Project	IEEE 802.16 Broadband Wireless Access Working Group < http://ieee802.org/16 >	
Title	H-ARQ support corrections, for OFDMA PHY mode from MAC perspective	
Date Submitted	2004-04-15	
Source(s)	<p>Yossi Segal, Yigal Leiba, Zion Hadad, Runcom Technologies Ltd.</p> <p>Panyuh Joo, Seungjoo Maeng, Jaeho Jeon, Soonyoung Yoon, Jaehee Cho, Geunhwi Lim, JungWon Kim, Hong Sung Chang, Yong Chang, TaeWon Kim</p> <p>Samsung Electronics Co. Ltd.</p> <p>Chulsik Yoon, Byung-Han Ryu</p> <p>ETRI</p>	
Re:	Sponsor re-circulation Ballot	
Abstract	H-ARQ support corrections, for OFDMA PHY mode from MAC perspective	
Purpose	Adoption of proposed changes into P802.16-REVd/D4-2004	
Notice	<p>This document has been prepared to assist IEEE 802.16. It is offered as a basis for discussion and is not binding on the contributing individual(s) or organization(s). The material in this document is subject to change in form and content after further study. The contributor(s) reserve(s) the right to add, amend or withdraw material contained herein.</p>

This contribution shows what changes on the standard ‘P802.16-REVd/D4-2004’ are required for support of H-ARQ from MAC perspective.

2 Changes to Chapter 6 : Gener

Figure 125—Construction of H-ARQ encoder packet

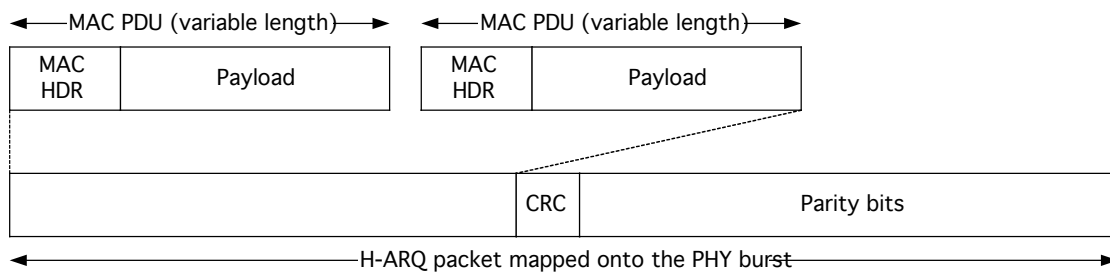
One or more MAC PDUs can be concatenated and an H-ARQ packet formed by adding a CRC to the PHY burst. Figure 125 shows how the H-ARQ encoder packet is constructed.

Each encoder packet is encoded according to the PHY specification, and four subpackets are generated from the encoded result. A subpacket identifier (SPID) is used to distinguish the four subpackets. In case of downlink communication, a BS can send one of the subpackets in a burst transmission. Because of the redundancy among the subpackets, SS can correctly decode the original encoder packet even before it receives all four subpackets. Whenever receiving the first subpacket, the SS attempts to decode the original encoder packet from it. If it succeeds, the SS sends an ACK to the BS, so that the BS stops sending additional subpackets of the encoder packet. Otherwise, the SS sends a NAK, which causes the BS to transmit one subpacket selected from the four. These procedures go on until the SS successfully decodes the encoder packet. When the SS receives more than one subpacket, it tries to decode the encoder packet from ever-received subpackets.

1. At the first transmission, BS shall send the subpacket labeled '00'.
2. BS may send one among subpackets labeled '00', '01', '10', or '11' in any order, ~~as long as the total number of transmitted subpackets does not exceed the maximum number of H-ARQ retransmission specified in CD message~~.
3. BS can send more than one copy of any subpacket, and can omit any subpacket except the subpacket labeled '00'.

Figure C.1 Reduced CID Decoding

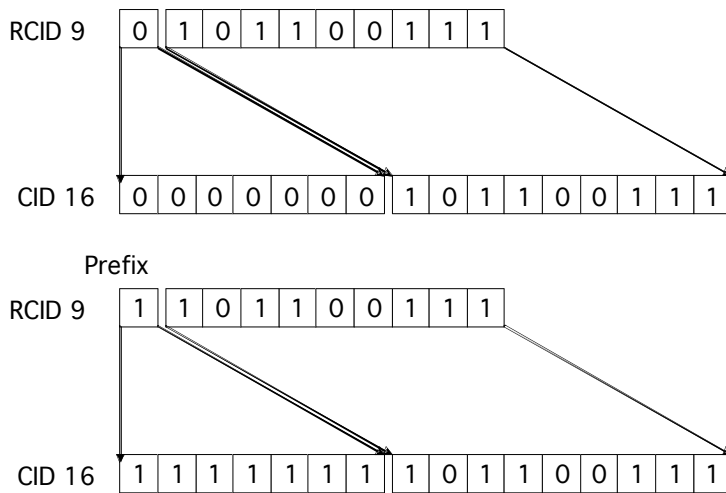
The BS enables Reduced CID when the basic CIDs of the all SS connected to the BS are less than 2048. The size of reduced CID depends on the range of basic CIDs and the minimum size of reduced CID is 7 bits excluding the prefix bit which indicates the broadcast, multicast and AAS CIDs. If the prefix bit is set to 1, the reduced CID size is 10 bits. The status and type of the reduced CID are specified by the Format Configuration IE.

When the reduced CID 9 is used in MAP_IE and the prefix is set to 0, the SS should decode the reduced CID by adding 7 bits of 0 at the MSB at the CID 9 resulting 16 bits CID. The reduced decoding procedure is presented in Figure C.1.
